AIP
Supplement 36/21
16 DEC 2021

A D : SEOUL/Gimpo INTL(RKSS)

OPERATIONAL RESTRICTIONS

3. TEMPORARY CHANGE OF RKSS AD

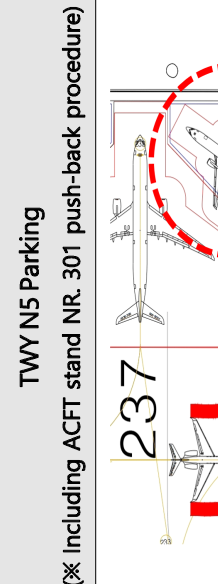
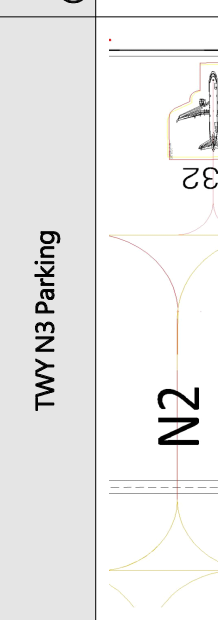
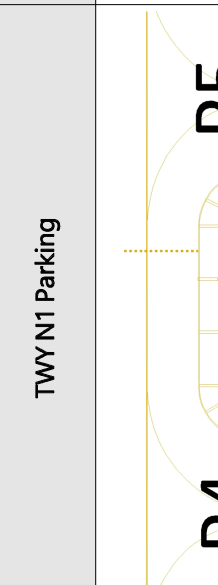
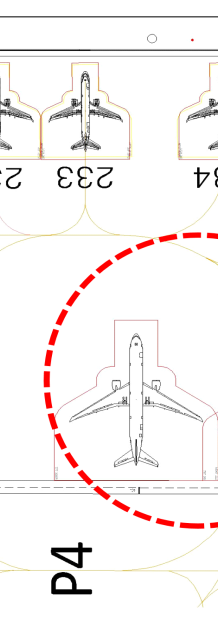
Paragraph	Current	Change	Remark
AD 2-11 2.3.1	All aircraft on P5 should wait at the waiting point on P5 if N1, N2, N3, or N4 is occupied by any aircraft.	All aircraft on P5 should wait at the waiting point on P5 if N1(except parked by C class ACFT or below), N2, or N4 is occupied by any aircraft.	
AD CHART 2-4	ACFT stands NR. 124-126, 131-134, 137, 201-202, 204 and 205 may be used by B767 class (A300-600) ACFT for Nose-in/Taxi-out subject to prior permission from ATC.	ACFT stands NR. 126, 131-134, 137 may be used by B767 class (A300-600) ACFT for Nose-in/Taxi-out subject to prior permission from ATC.
